ENCLOSURE 5 TO NL-09-036

Applied Science Associates, Inc. Report dated March 16, 2009,
"Review of Thermal Discharge Issues to the Hudson River in NRC Draft
SEIS for Indian Point 2 and 3"

ENTERGY NUCLEAR OPERATIONS, INC
INDIAN POINT NUCLEAR GENERATING UNIT NOS. 2 and 3
DOCKETS 50-247 and 50-286

**Review of Thermal Discharge Issues to the Hudson
River in NRC Draft SEIS for Indian Point 2 and 3**

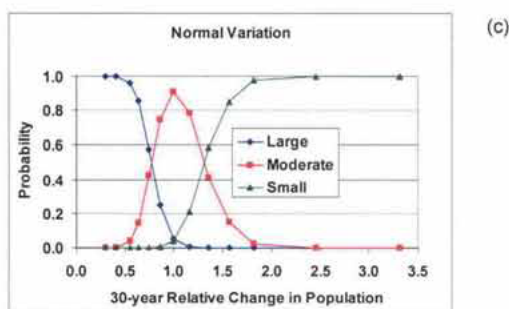
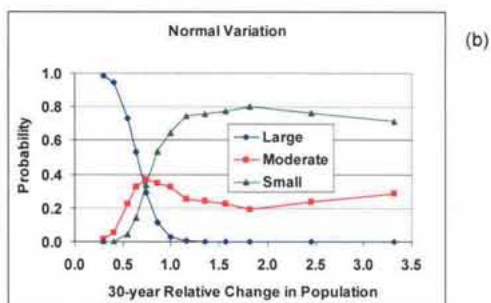
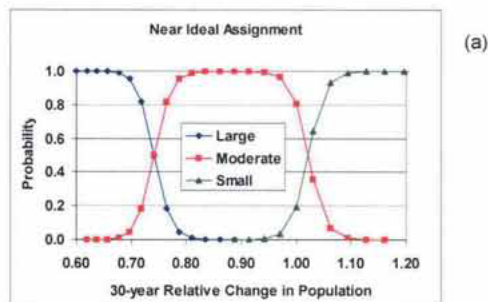
Classification probabilities for an "ideal" procedure are illustrated in figure 1a, and the probabilities calculated for NRC's classification procedure are illustrated in figure 1b. In Figure 1a, the ranges of population change over which more than one classification is possible are small (~0.65 to ~0.85 and ~0.95 to ~1.1), and there are no rates of population change for which more than two classifications are possible. As shown in Figure 1b, probabilities of misclassification are high using NRC's procedure. There is a 20%-40% chance that a trend will be classified as Moderate for population

To illustrate the potential for improvement of the classification process, a simpler set of rules was applied to the simulated data (Appendix A). This scheme produced Large, Moderate, and Small classifications that were much more distinct than those produced by NRC's rules (Figure 1c). Separation of the Large and Small categories was nearly complete, and a Moderate category centered on relative change ≈ 1 , where the probability of Large and Small was very low. The zones of overlap of two categories, either Large with Moderate or Moderate with Small, are much smaller than with the classification rules used by NRC. This alternate classification is still conservative, because population that are growing, but at a relatively low rate (up to about a 120% increase over 30 years) have a higher probability of being incorrectly classified as Moderate than of being correctly classified as Small.

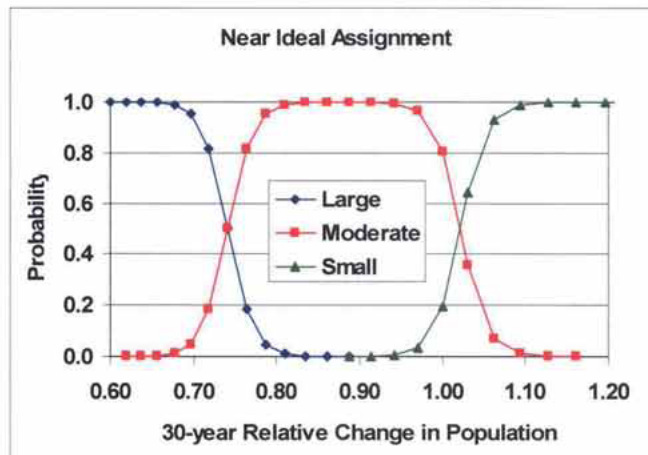
Ideally, a classification process would be able to delineate distinct classes based on true values of population parameters. An ideal classification process would have large ranges of population change where only one of the classes is possible, and small ranges where probabilities for two classes overlap (Figure B-2). The nearly ideal hypothetical classification depicted has uncertainty in classification only when 30-year relative change in the population is near 0.75 or 1.05. In each case the uncertainty is only between two of the three classes.

Figure B-3 Classification under NRC decision rules of simulated population abundance data with normal variation around the expected value, $\delta = 0.25$. Probabilities for the three classifications always sum to unity.

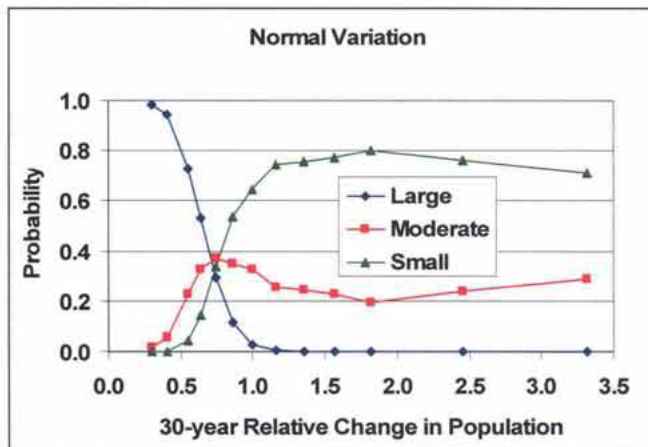
The NRC process, for a population with normal variation in annual abundance and $\delta = 0.25$, departs substantially from the ideal (Figure B-3). The delineation between the Large and Small categories of potential impact was relatively distinct, with overlap of the categories occurring only in the range of 0.5 to 1.0 relative change in population size. However, the probability that a population could be classified as Moderate potential impact was between 0.2 and 0.4 for population change ranging from 0.5 to 3.3, i.e. a population that had declined to 50% of its original abundance and a population that had grown to more than 3 times its original abundance have essentially the same probability of being classified as Moderate potential impact. The probability that a population would be classified as having a Large potential impact was also non-trivial for populations that had declined relatively little: 0.32 for a trend resulting in 0.7 of initial abundance, 0.12 for a trend resulting in 0.9 of initial abundance, and 0.03 for a population with unchanged abundance. The 0.6 to 0.9 range in population change is a zone in which discrimination is highly uncertain as the probabilities of the Large potential impact category range from 0.53 to 0.11; probabilities of the Moderate category range from 0.33 to 0.37; and probabilities of the Small category range from 0.14 to 0.65.

Figure B-4 Classification under NRC decision rules of simulated population abundance data with log-normal variation around the expected value, $\delta = 0.25$. Probabilities for the three classifications always sum to unity.

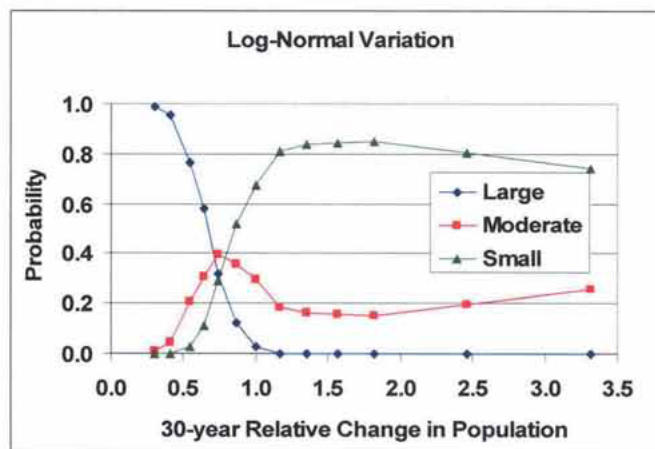
If population variation is lognormal rather than normal, the operating characteristics of the NRC classification are essentially the same (Figure B-4), although

between relative population change from about 1.2 to 2.5 the probability of a population being classified as Moderate impact declines slightly below 0.2.

Figure B-5 Classification under NRC decision rules of simulated population abundance data with normal variation around the expected value, $\delta = 0.25$, after applying a 3-year moving average. Probabilities for the three classifications always sum to unity.

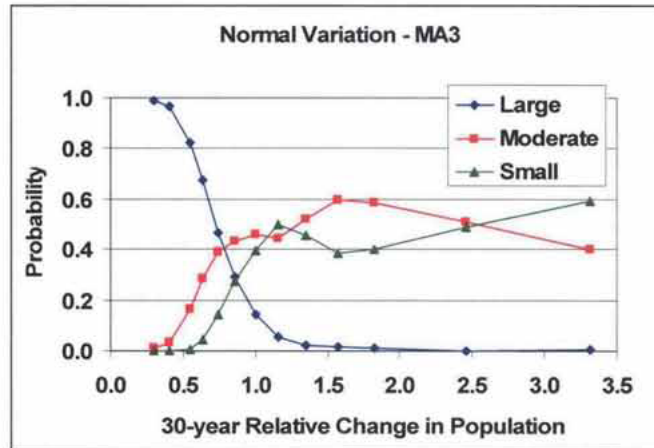
Smoothing the data series with a 3-year moving average prior to analysis resulted in the classification process being even less able to distinguish Moderate from Small impact. Populations that increased in abundance (population change greater than 1.0) had nearly equal likelihood of being classified Small or Moderate (Figure B-5).

Figure B-6 Classification under NRC decision rules of simulated population abundance data with normal variation around the expected value, $\delta = 0.10$. Probabilities for the three classifications always sum to unity.

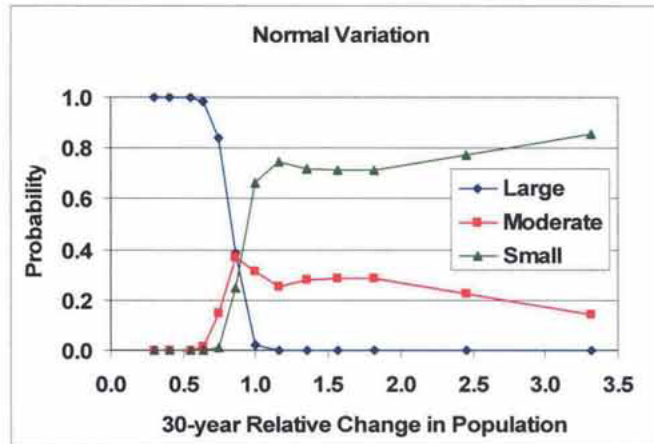
Simulation results for less variable population abundances, $\delta = 0.10$, were also qualitatively similar although the probability of a Moderate classification began to drop below 0.2 at population changes above 2.5 (Figure B-6).

Figure B-7 Classification of simulated population abundance data with normal variation around the expected value, $\delta = 0.25$, under rules based on significant positive or negative slopes, each considered significant if $p < 0.10$. Probabilities for the three classifications always sum to unity.

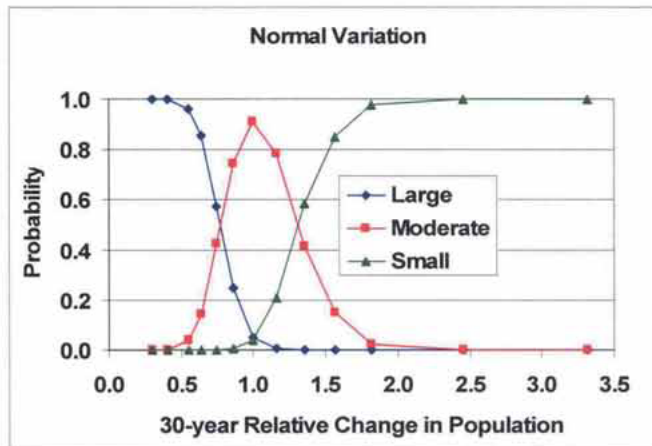
This rule resulted in nearly complete separation of the Large and Small categories, and a Moderate category centered on relative change = 1, where the probability of Large and Small was very low (Figure B-7). The zones of overlap of two categories, either Large with Moderate or Moderate with Small, are much smaller than with the classification rules used by NRC. This classification scheme may or may not be preferable for NRC's purpose, but it illustrates that different sets of rules can produce very different classifications for the same data, and that no classification scheme should be used without first testing its performance on data with known characteristics.

Figure 1. Map of Westchester County showing proximity of Indian Point to Potential Environmental Justice Areas (PEJA) in purple, with approximate location of United Water of NY's proposed desalination plant in Rockland County.
 Courtesy of NYS DEC Office of Environmental Justice.

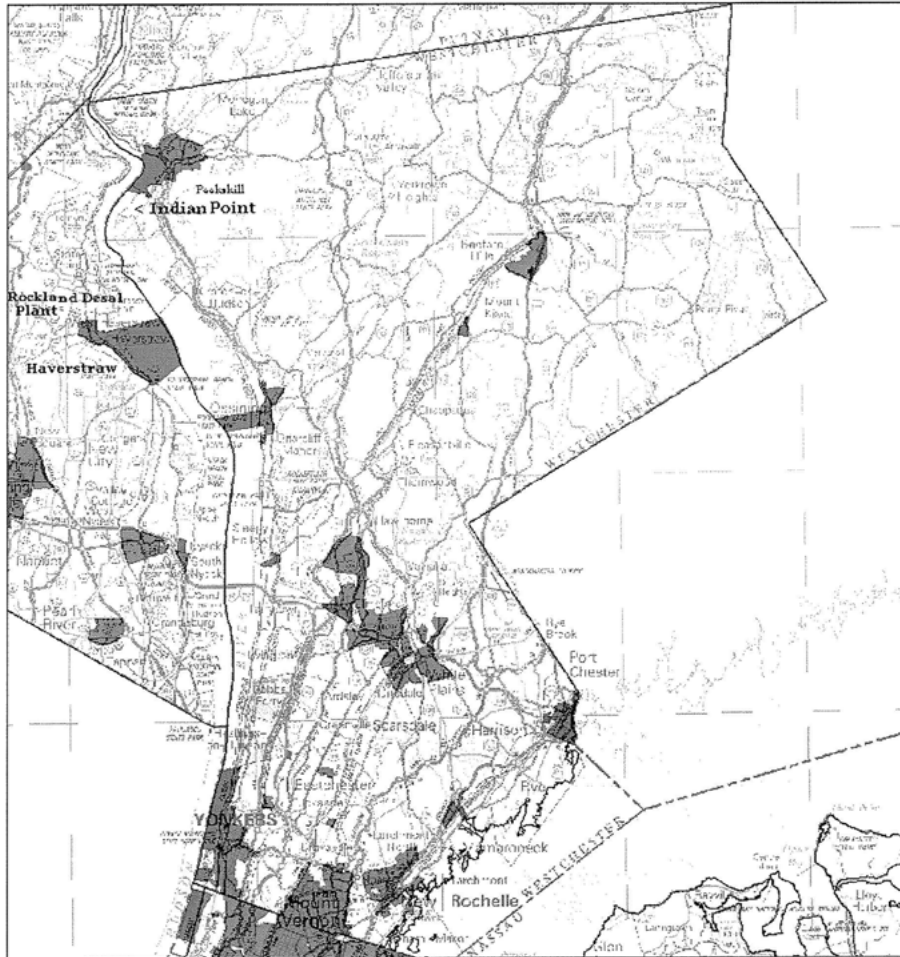
Given the potential impact upon the planned Rockland County water treatment plant (and upon other communities in the lower Hudson that take drinking water from the Hudson River), the deficiencies are substantial and the impacts may have direct adverse consequences upon human health. Because of the seriousness of this issue, Clearwater is filing a contention in the relicensing proceeding to require both Entergy and NRC staff to consider these impacts.
